Hitachi Single-Chip Microcomputer

Technical Questions and Answers

H8/500 Series

Product	H8/500	Q&A No.	QA500 - 002B
Topic	EXTAL and system clock output line

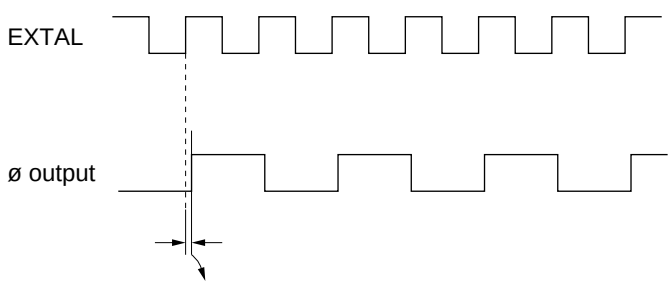
1. During external clock input, what is the phase relationship between EXTAL and the system clock output line (ø output)?

1. During external clock input, the phase relationship between EXTAL and the system clock output line is as shown below.

Approx. 40 ns internal delay

The internal delay value is not guaranteed.

Product	H8/500	Q&A No.	QA500 - 006B
Topic	External clock input to 16-bit FRT

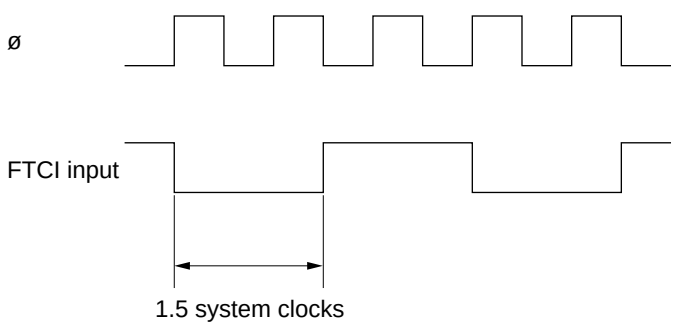
1. When the external clock source is selected for the 16-bit free-running timer, what is the minimum pulse width of the external clock (FTCI)?

1. The minimum pulse width of the external clock is 1.5 system clock cycles.

FRC Access Timing (read)

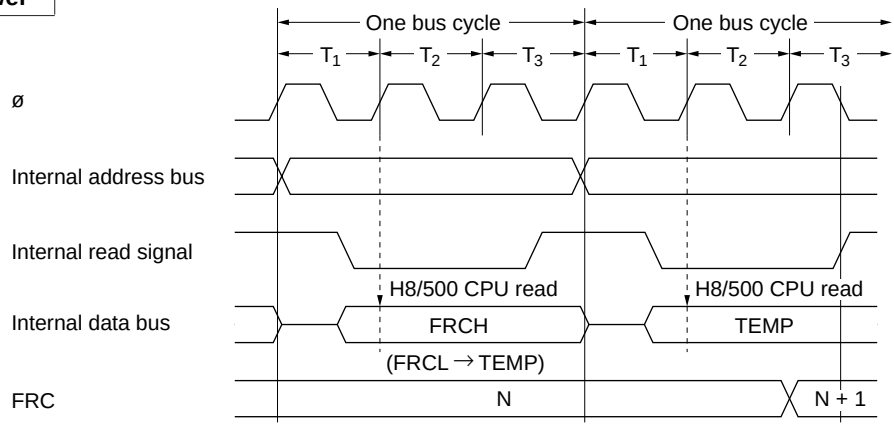
1. What is the read and write timing of the free-running counter (FRC) in the 16-bit free-running timer (FRT)?

Operation when register is read

When the upper byte is read, the upper byte value is passed to the CPU and the lower byte value is transferred to TEMP. Next, when the lower byte is read, the lower byte value in TEMP is passed to the CPU.

8-Bit Data, 1 Stop Bit, Internal Clock

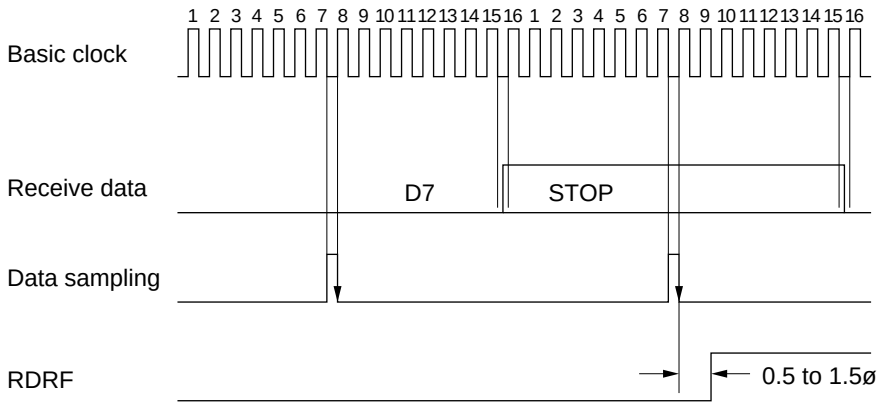
1. When data reception is completed, the receive data register full bit (RDRF) in the serial status register (SSR) is set to 1. At what timing does this occur in asynchronous mode?

1. The RDRF bit is set to 1 after the fall of the next data sampling clock after the MSB of the data is received. (See the diagram below.)

8-Bit Data

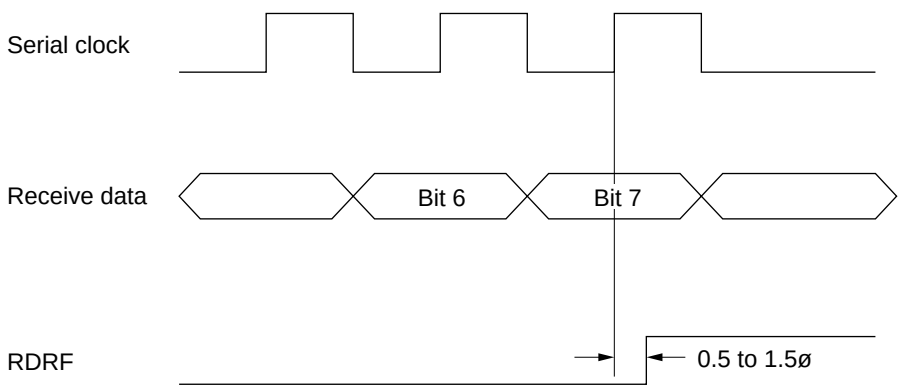
2. At what timing does this occur in clocked synchronous mode?

2. The RDRF bit is set to 1 after the rising edge of the serial clock cycle in which the MSB of the data is received. (See the diagram below.)

1.1 Transmit data present in TSR (see diagram below)

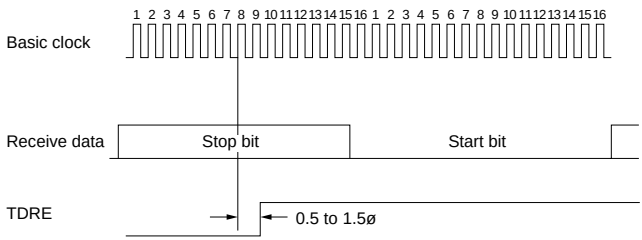
1. When eight data bits have been transmitted, the transmit data register empty bit (TDRE) in the serial status register (SSR) is set to 1. At what timing does this occur in asynchronous mode?

The TDRE bit is set to 1 at different times depending on whether the transmit shift register (TSR) contains transmit data or not.

The timing of the start of transmission after the transmit enable bit (TE) is set is similar.

2.1 Transmit data present in TSR (see diagram below)

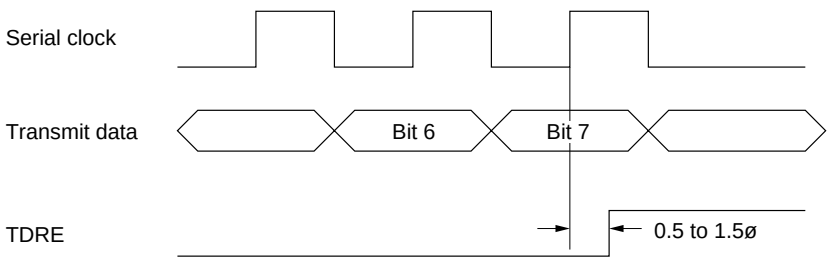
2. At what timing does this occur in clocked synchronous mode?

Reception of 8-Bit Data

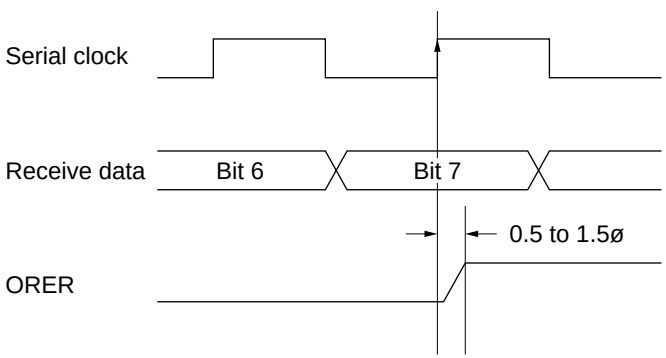
1. When the SCI is used in clocked synchronous mode, at what time is an overrun error detected?

1. The overrun error bit (ORER) is set to 1 after the rise of the serial clock when the most significant data bit (bit 7) is received.

Product	H8/500	Q&A No.	QA500 - 053A
Topic	SCI transmit start (asynchronous mode)

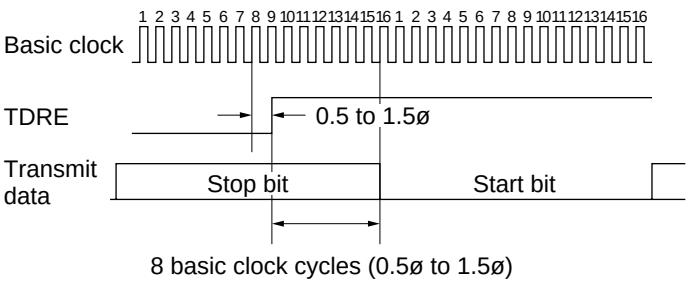
1. In the SCI transmitting sequence, following the transfer of data from TDR to TSR, the transmit data register empty bit (TDRE) in the serial status register (SSR) is set to 1, then the SCI starts transmitting data. How much delay is there from the time when the TDRE bit is set to 1 until output of the start bit?

1. The delay time is eight basic clock cycles (0.5ø to 1.5ø). See the diagram below.

The same timing applies when transmission starts from the setting of the transmit enable bit (TE).

Product	H8/500	Q&A No.	QA500 - 025B
Topic	Non-use of A/D converter reference voltage lines (AV_{CC}, AV_{SS})

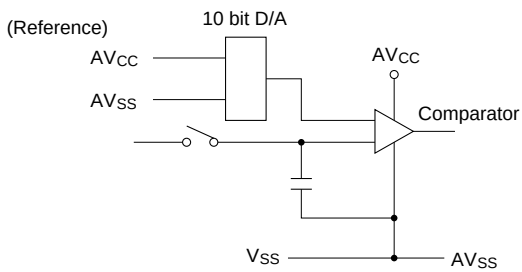
1. When the A/D converter is not used, what should be done with the AV_{CC} and AV_{SS} pins?

1. Even when the A/D converter is not used, AV_{CC} should be connected to V_{CC} and AV_{SS} to V_{SS}.

(1) If AV_{CC} is left open, voltage potentials in the interface to the digital circuits in the A/D converter will be unstable.

(2) AV_{SS} and V_{SS} are shorted inside the chip. Any potential difference between them will cause excessive current drain.

Product	H8/500	Q&A No.	QA500 - 029B
Topic	Rise time of power supplies (AV_{CC}, V_{CC})

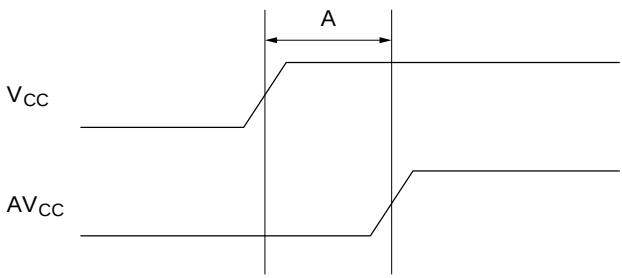
1. Will any problems occur if there is a difference in rise times between the analog power supply (AV_{CC}) and digital power supply (V_{CC})?

1. There is no restriction on the order in which AV_{CC} and V_{CC} are powered up.

During the interval marked A in the diagram below, voltage potentials in the interface to digital circuits in the A/D converter are unstable, which may cause fluctuations in current drain.
